***MODIFICATION REQUEST:
NorthConnex Modification 2***

***Modification to Condition B2 -
Ventilation Outlet Heights
SSI 6136 (MOD 2)***

Environmental Assessment Report
Section 115ZI of the *Environmental
Planning and Assessment Act 1979*

February 2018

Figure 2. Updated visual catchment mapping of the proposed tip height increased of the northern ventilation outlet (Source: Proponent's Modification Request)

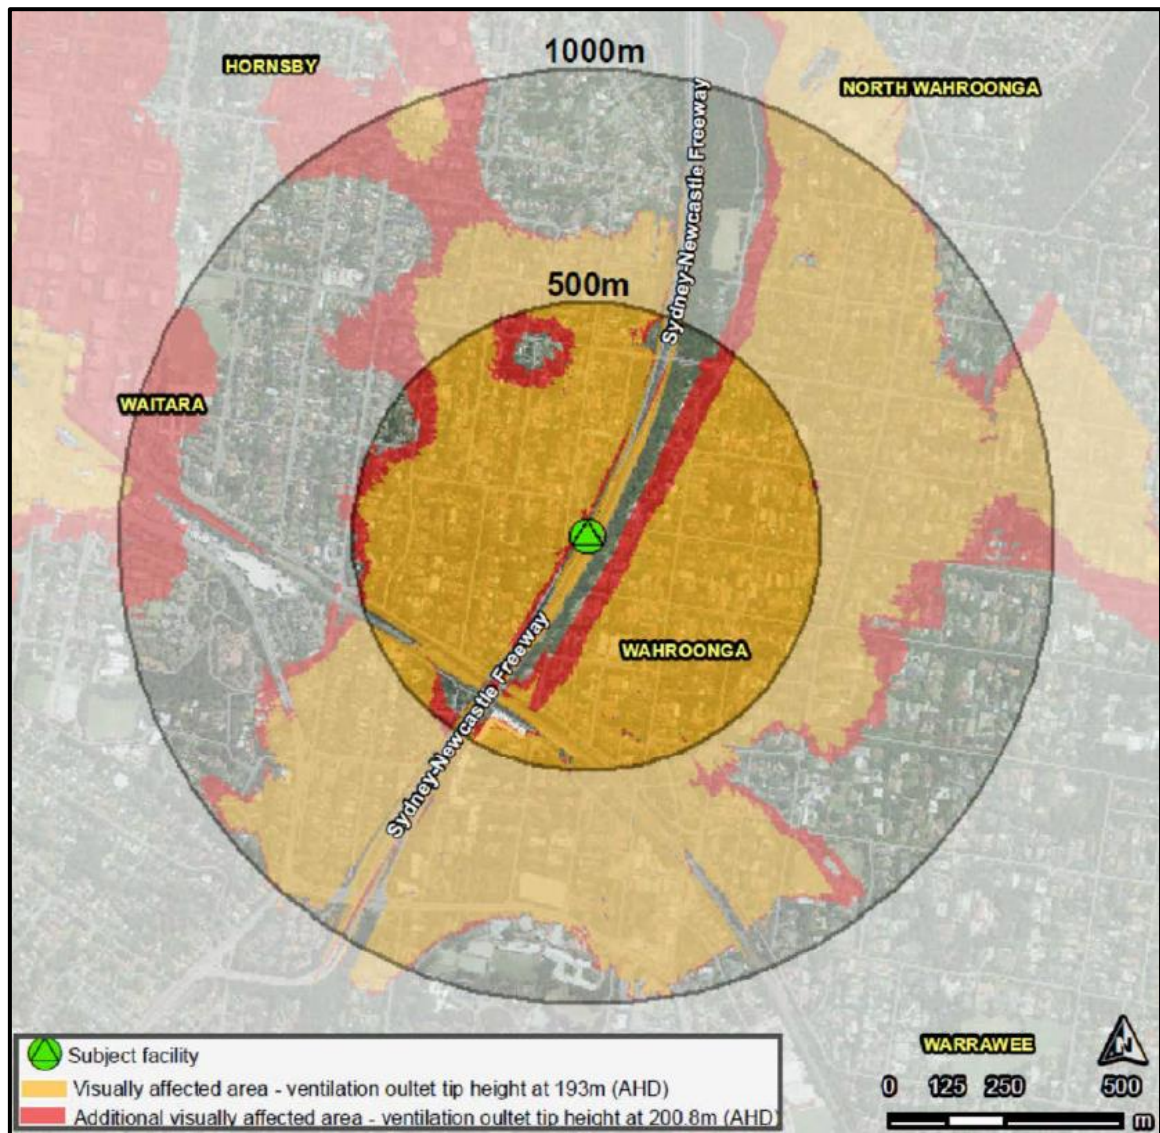
Consistent with the EIS, the Proponent has assessed the visual impacts of an increased outlet height for a visual catchment of up to one kilometre surrounding the northern ventilation outlet. **Figure 2** indicates the areas where additional receivers may be able to see the higher ventilation outlet.

The Department acknowledges that increasing the height of the northern ventilation outlet by 6.8 metres above that approved for the original project would make it visible from more vantage points. However, it is also acknowledged that the catchment presented in **Figure 2** is based on topography alone and does not take into account potential obstructions such as vegetation or buildings. As such, the Department considers this approach to be conservative.

Whilst a greater number of receivers may be able to view a higher outlet, this impact is likely to diminish or be obscured with increased distance. Additionally, it is likely that any views beyond those receivers immediately adjacent to the site of the outlets will be partial. The Department considers that the urban design treatments to be applied to the ventilation facilities will assist in mitigating visual impacts.
